Exeter Airport Airspace Change Proposal

Options Development

| Reference | Description |
|-----------------------|---|
| Document Ref | 71189 031 |
| Client Name | Exeter & Devon Airport Ltd |

A4.3 Option 3

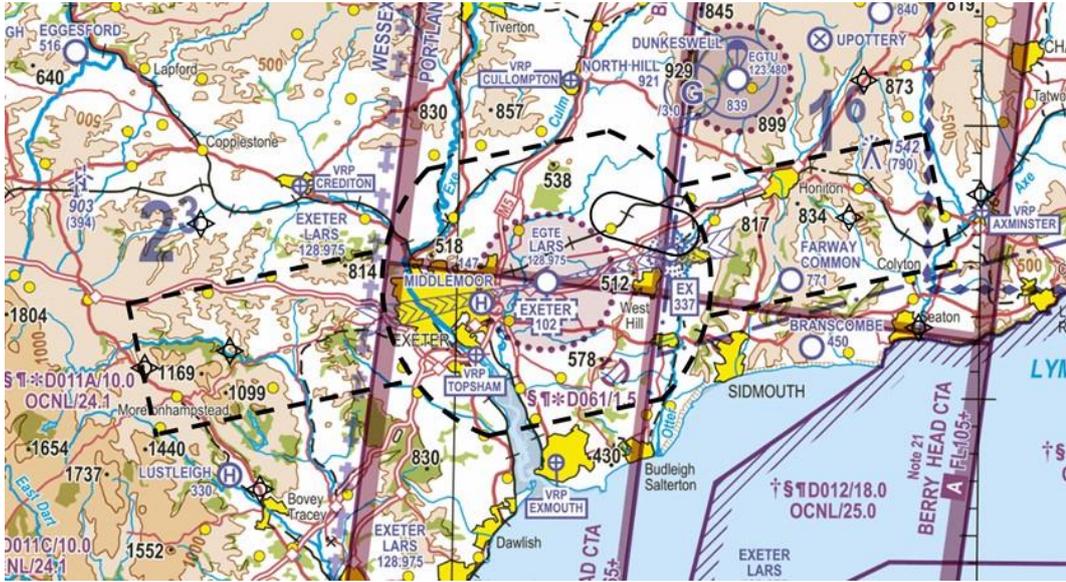
Exeter Airport notes the comment that Option 3 as presented might be a viable option. Despite considering this option to be unviable, Exeter Airport will include this option, with extended stubs, going forward.
